Revised 100GBASE-SR4 Tx and Rx specifications

IEEE P802.3bm, September 2014, Ottawa

- TxVEC of 5 is:
 - higher than any other optical PMD
 - near a cliff
 - higher than VECP of 4.2, and
 - higher we intended
- This presentation gives revised values for TxVEC in Tx spec, and consequential changes to Tx, Rx and budget tables
- Relevant to comments 32, 70, 71, 43

Simulated eye with TDP approaching 5 dB

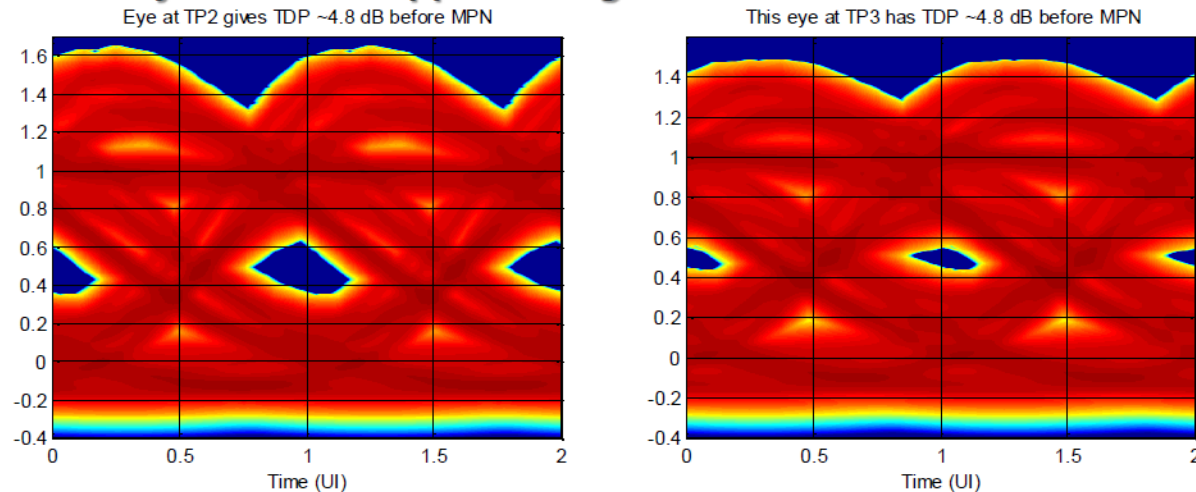
- TDP like Clause 52: +/-0.05 UI, but:
 - BER = 5e-5
 - 100 m of OM4 modelled as a Gaussian filter, like spreadsheet model
 - Standard fourth-order Bessel-Thomson
- Includes ISI from chromatic dispersion but not MPN
- Is this on the cliff edge?

TDP vs. signalling rate

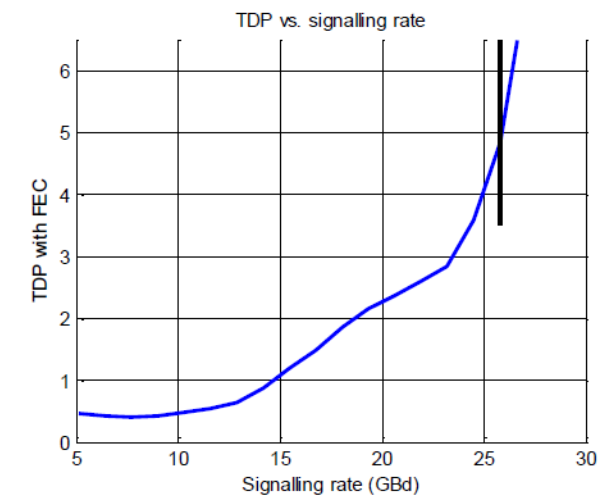
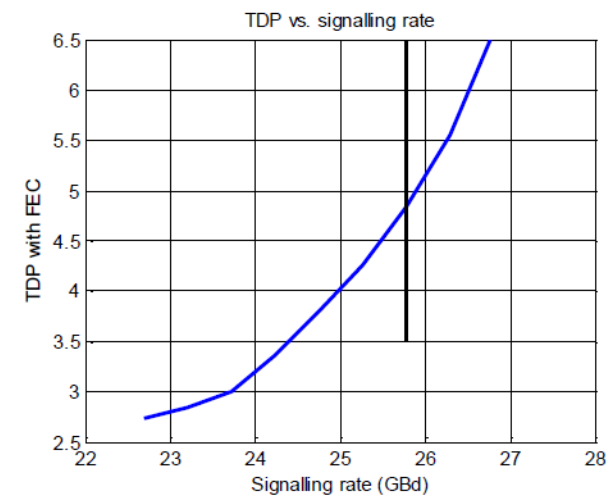
- IC bandwidths scaled with signalling rate, laser not scaled
- 2% rate change increases TDP by 0.7 dB – yes, cliff edge

- Slide 12 of daw_e_02a_0114_optx, slides 4, 5 of daw_e_01_0513_optx
- This eye is on the "cliff edge": about to collapse
- Since this work, widening the decision timing offsets and changing to TxVEC has helped
- TxVEC limit should be reduced from 5 dB

TxVEC of 5 is higher than VECP of 4.2

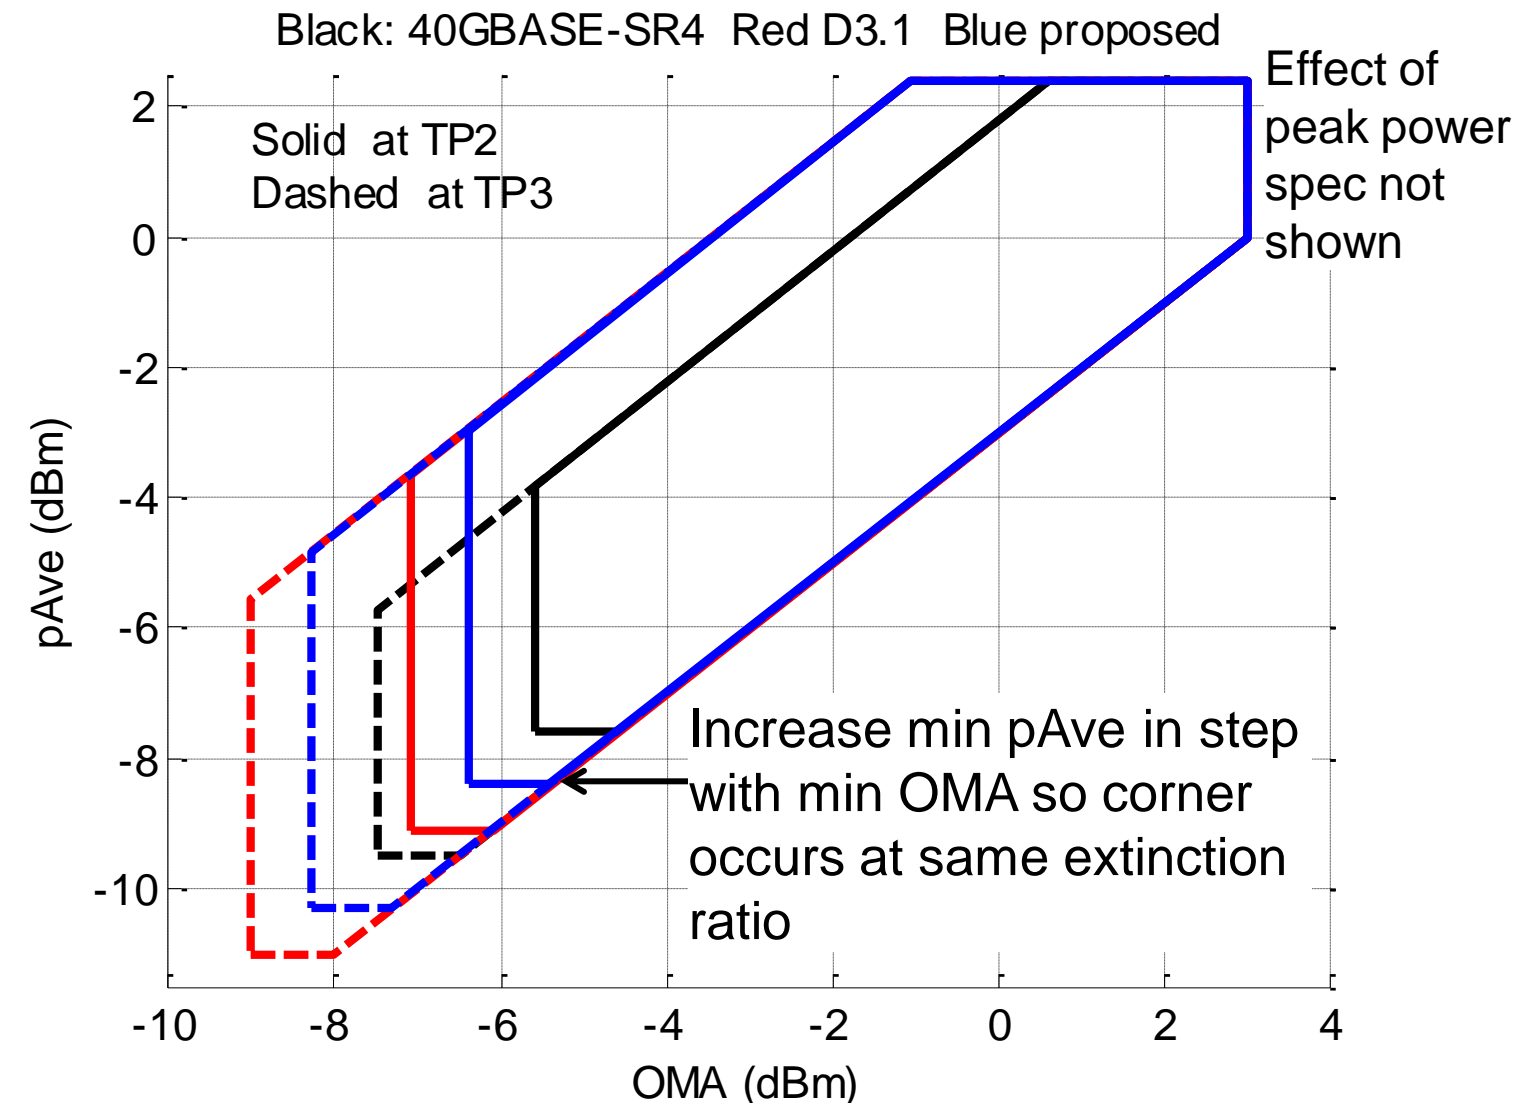
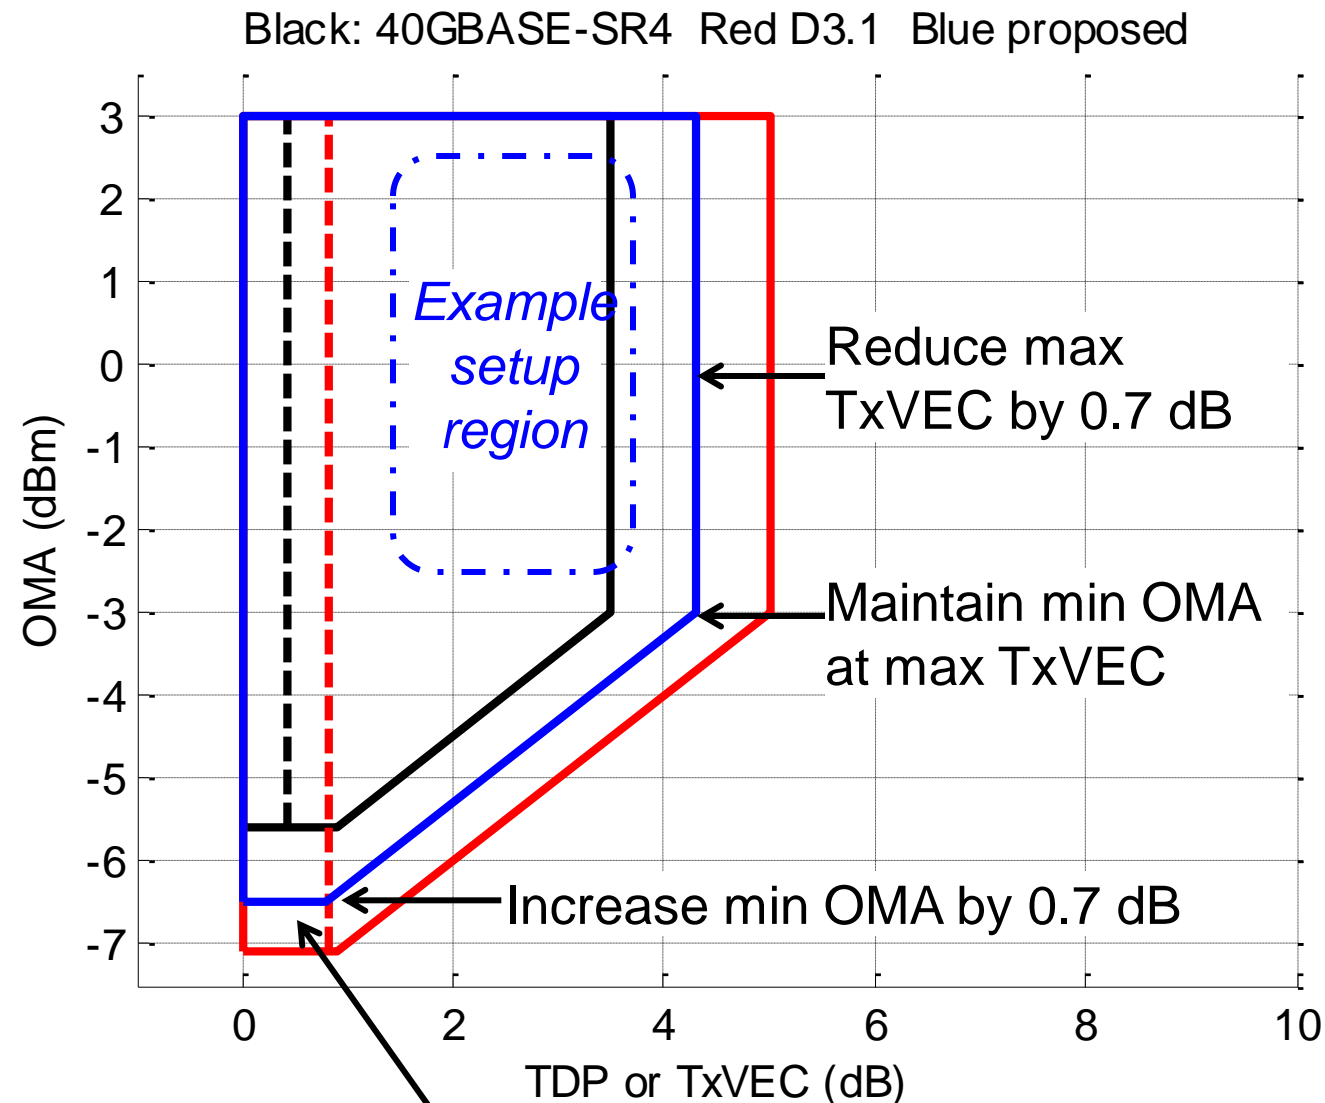
- Often, for the same signal, TxVEC is significantly lower than VECP
 - Whether it's TxVEC for a transmitter or a (different) TxVEC metric for a receiver
- This is partly because VECP was suitable for $1e-12$ BER; an indifferent signal's penalty is less at $5e-5$ than $1e-12$
- And also because VECP is affected by measurement noise
- The factors outweigh the decision timing offsets in TxVEC
- TxVEC for the receiver should be less than the 4.2 dB VECP in the draft
- TxVEC for the transmitter should be not much more than that
